- 5) Please confirm the same antenna element was used as the original approval. The original shows:

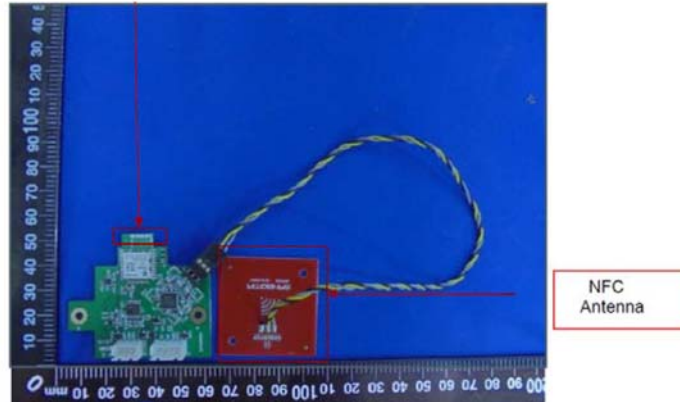
- 7) This result is nearly 14 dB lower than the original. Is this expected? Was various positions of the TX antenna investigated?

Also note that the NFC output level was significantly reduced by the addition of the dampening resistor added to the antenna. The coil has remained the same.
